Permit No: 0009234

Site Address: 44 PARKSHORE CR SAC

Nature of Work: REROOF DURLITE TILE 35 SQS. RAIN GUTTERS, DRY ROT.

SUBJECT: Roof structural inspection at 44 Park Shore Circle, Sacramento, CA 95831

SEE PLAN SHEET
 #1 BEARING WALL
 EACH END OF 95'

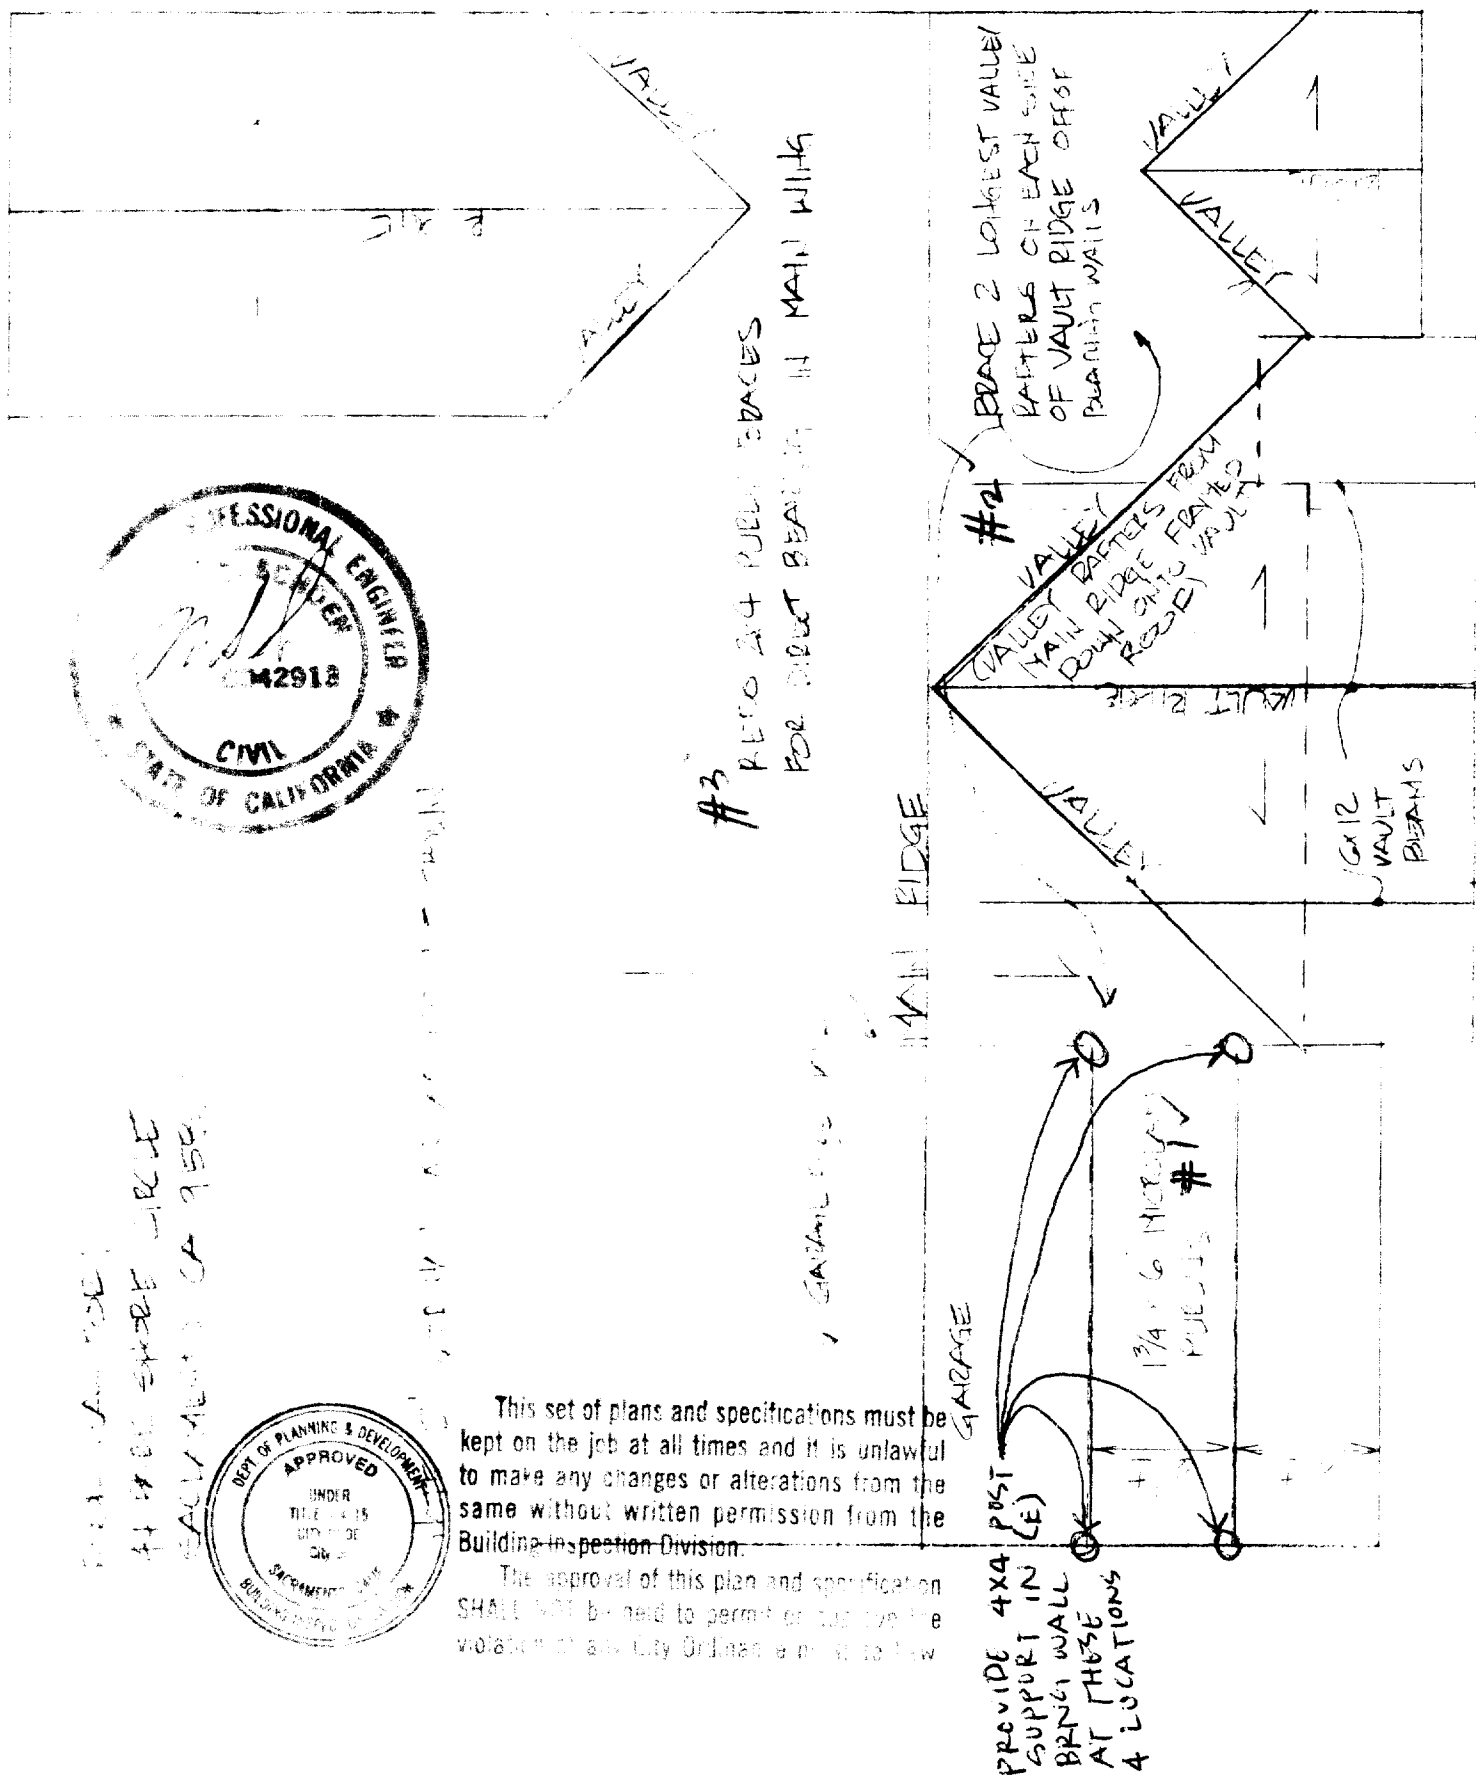
- #1 * The rafters in the garage are overspan. Install two 1-3/4"x16" Microlam purlins in the garage one about 6' back from the garage door and one about 12' back(see attached sketch for details).

- #3 * Some of the purlin braces in the attic areas of the house are framed so as to run by the purlin and then rely on nailing and a 2x4 block nailed to the brace underneath to support the purlin. These are not adequate to support the proposed roof loads and should be redone. These braces should either be replaced by braces providing direct bearing for the supported member or modified to provide direct bearing(see sketch for details and plan for location).
